SUBDIVISION REPORT - CONCEPT/USE ON REVIEW

► **FILE #:** 7-SA-21-C **AGENDA ITEM #:** 18
7-C-21-UR **AGENDA DATE:** 9/9/2021

► **SUBDIVISION:** MISSION HILLS
► **APPLICANT/DEVELOPER:** SCOTT SMITH, S & E PROPERTIES, LLC
OWNER(S): Scott Smith / S & E Properties, LLC

CONCEPT PLAN
SITE LAYOUT

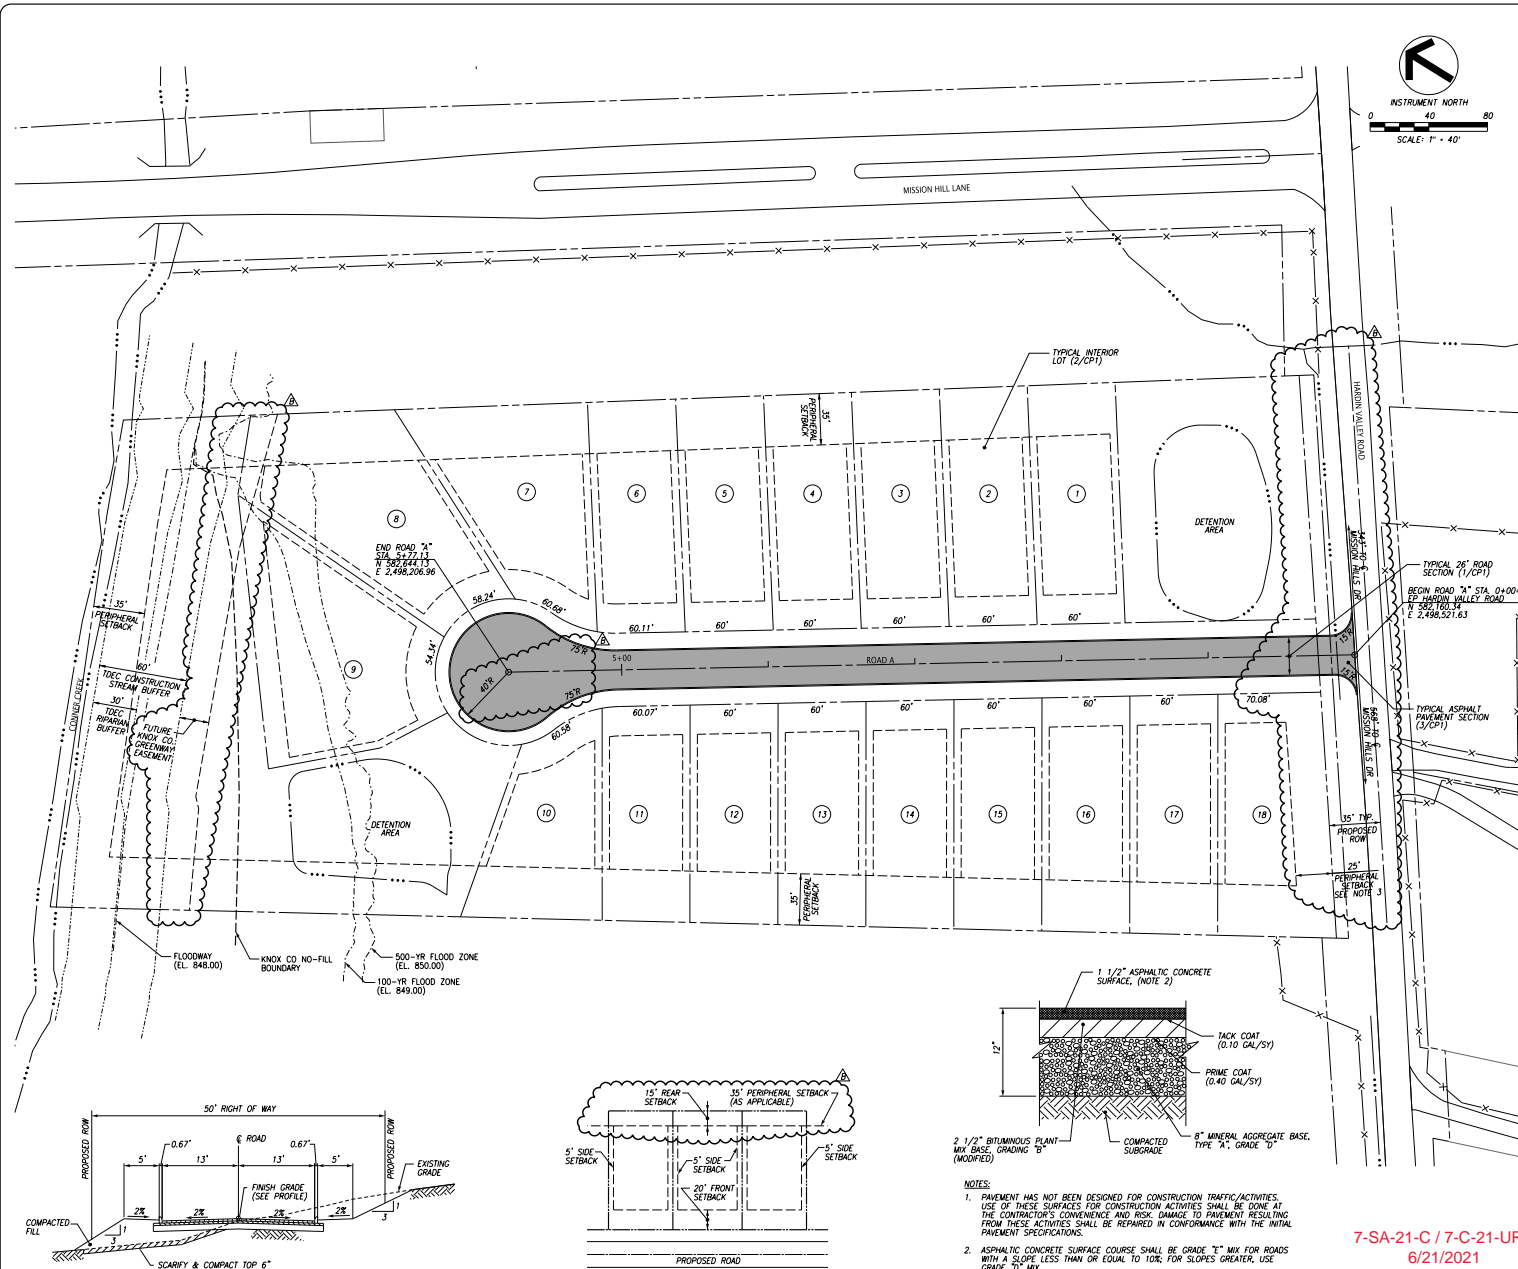
► **SUBDIVISION VARIANCES REQUIRED:**
1) REDUCE THE VERTICAL CURVE (CREST) K VALUE FROM 25 TO 20 AT VPI STA 3+10.00 ON ROAD 'A'.
2) REDUCE THE MINIMUM DISTANCE BETWEEN MISSION HILL LANE AND ROAD 'A' FROM 400-FT to 343-FT.
3) REDUCE THE VERTICAL CURVE (SAG) K VALUE FROM 25 TO 15 FOR THE INTERSECTION OF ROAD 'A' AND HARDIN VALLEY ROAD.

Approve variance 3 subject to the existing or dedicated right-of-way for Hardin Valley Road being 40-ft from the road centerline and the peripheral setback for lot 18 being no less than 30-ft along the Hardin Valley Road frontage.

3. Providing a 25-ft radius for the property lines and curbs at the intersection of Road 'A' and Hardin Valley Drive per the Subdivision Regulations (section 3.04.J.2) or obtaining approval of a variance by the Planning Commission.

4. If the existing Hardin Valley Road right-of-way is greater than 35-ft along the frontage of the property, the applicant must obtain approval from Knox County Commission to close a portion of the Hardin Valley Road right-of-way so it is 35-ft from the centerline of the road as proposed on the concept plan. If the existing right-of-way is less than 35-ft, then the 35-ft right-of-way must be dedicated as required by the Major Road Plan.

6. Correcting the peripheral setback in general note #3 on the concept plan, as needed.
7. If the Hardin Valley Road access is removed and an alternative access is provided through the adjacent property to the west, extension of the access through the subject property can be approved as part of a concept plan for the adjacent property.

CONCEPT
 GRADING PLAN
 AND ROAD PROFILE

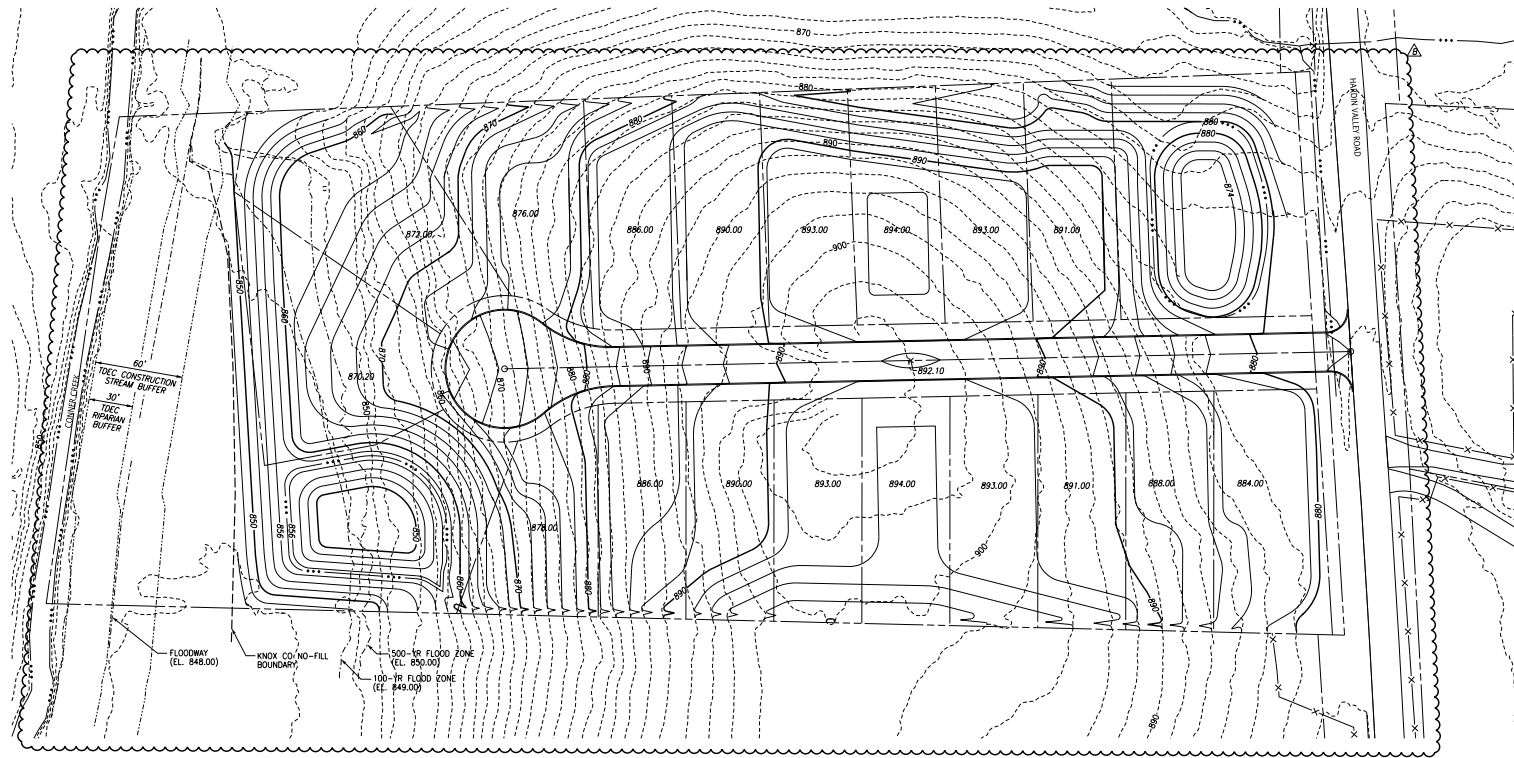
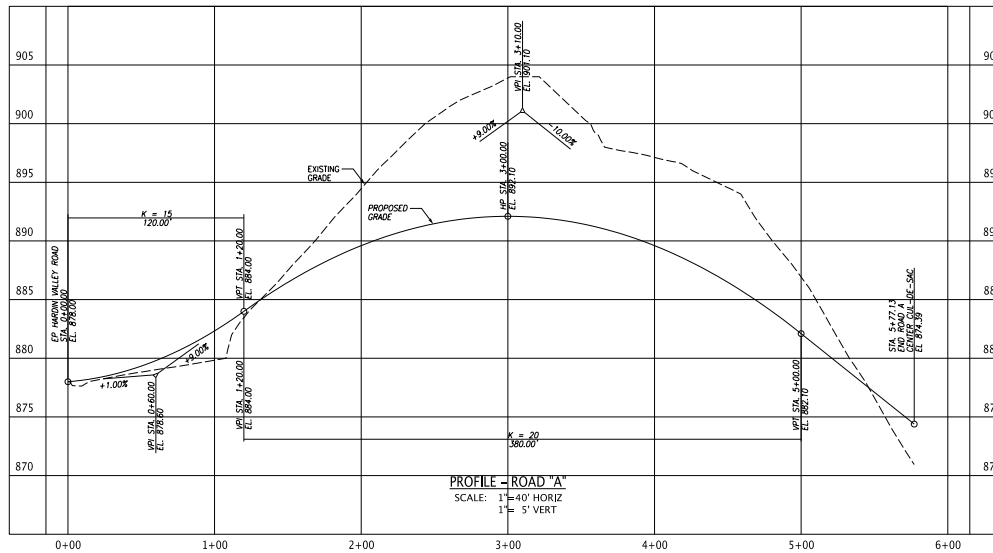
This proposal is for an 18-lot residential subdivision on approximately 6.98 acres at a density of 2.58 du/ac. The property was recently rezoned from A (Agricultural) to PR (Planned Residential) up to 3 du/ac (1-G-21-RZ). Access to the site is from Hardin Valley Road and will require approval of a variance to reduce the minimum distance between the Mission Hill Land and Road 'A' intersections from 400-ft to 343-ft, which staff is supporting. A greenway easement will be provided along the south side of Connor Creek, with the final location and width of the easement to be determined during the design plan phase. Approximately 3.83 acres of the 6.98-acre site is within the Hillside Protection (HP) area (see the attached slope analysis). The maximum recommended land disturbance within the HP area is 2.6 acres (approximately 68 percent of the HP area). Based on the grading plan, it appears that nearly 100 percent of the HP area on this site will be disturbed (sheet CP2).

The connecting vertical curve ("k value") is the transition of the grade of Road 'A' from 9 percent to 1 percent as it approaches the Hardin Valley Road intersection. The lower the k value, the more abrupt the transition between the two road grades. At intersections with a classified street (collector or arterial), the minimum k value is 25 which allows for a smoother transition from the smaller local road to the larger classified street. This larger k value also allows the classified street to be expanded in the future and to more easily tie in grades of side streets, such as the proposed road. For this request, if the existing Hardin Valley Road right-of-way is 40-ft, the County does not anticipate the need for additional right-of-way acquisition and the k value of 15 should not impact the ability to tie Road 'A' into the new intersection and will not greatly impact lot 18. If the Hardin Valley Road right-of-way is less than 40-ft, the County believes lot 18 could be impacted because of the need to reconstruct more of Road 'A' to tie in the grades properly, as well as needing to grade into the property more along the Hardin Valley Road frontage to accommodate the expanded road.
